CITY OF MERIDIAN FINDINGS OF FACT, CONCLUSIONS OF LAW AND DECISION & ORDER

Case No(s). H-2021-0088

SUBJECT: AZ, PP - H-2021-0088

Quartet South Subdivision

B. Preliminary Plat (date: 1/25/2022-2/25/2022)

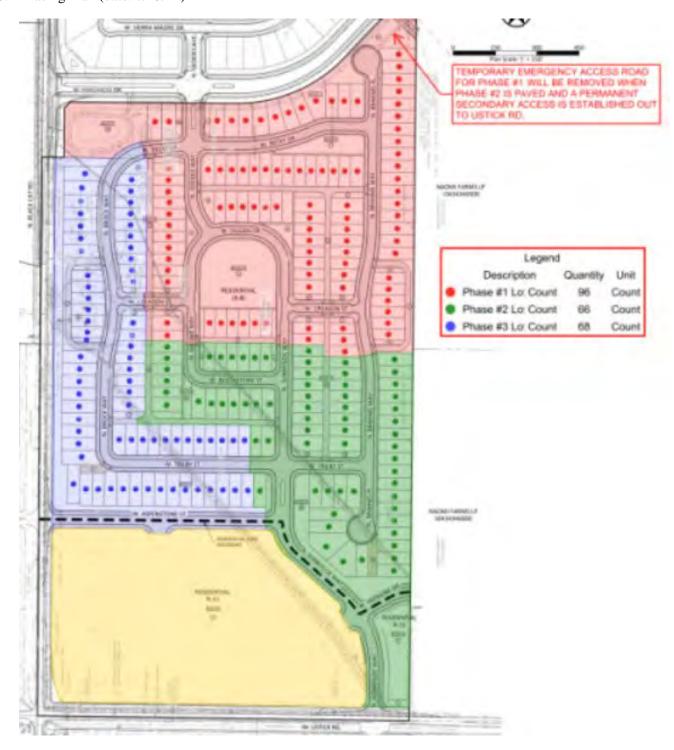
UDC 11-6C-3-B-5 states "alleys shall be designed so that the entire length is visible from a public street." The plat reflects alleys that are aligned north – south and intersect with another alley in a "t-intersection" that does not allow visibility of the entire alley from a public street. UDC 11-5B-5 does not allow alternative compliance from this requirement. The plat must be revised accordingly, such as extending these alleys.

increase in block length to 1,000 feet if a pedestrian connection is provided. Staff has reviewed the submitted plat for conformance with these regulations. It does appear this limit is exceeded along the eastern boundary of the property. The applicant should revise the plat to the meet the requirements of UDC 11-6C-3.

- 2. The Preliminary Plat included in Section VI, dated 2/25/2022, is approved with the following revisions:
 - a. The plat should be revised to provide a transition between the east property line and the adjacent property to the east. Staff recommends a north south road along the eastern property line.

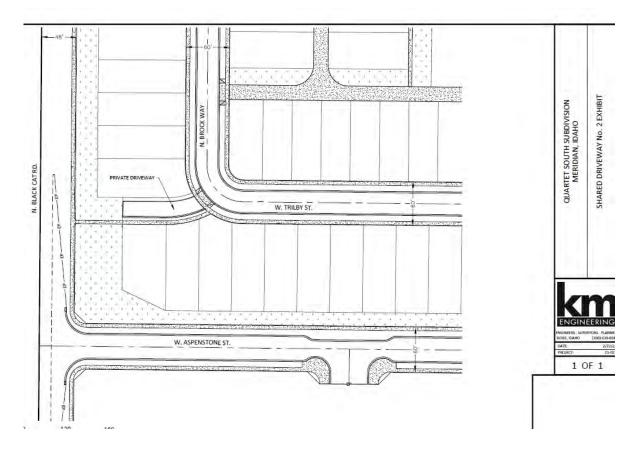
It does appear that the project meets the minimum open space requirements, although there are portions of Lot 13 of Block 2, Lot 7 and 43 of Block 6, and Lot 6 of Block 9 that do not meet the minimum required 20 ft. width to be credited as open space. The open space exhibit should be revised accordingly.

- 4. Prior to City Council, the open space exhibit shall be revised to remove any areas of less than 20 ft. in width from being credited as qualified open space.
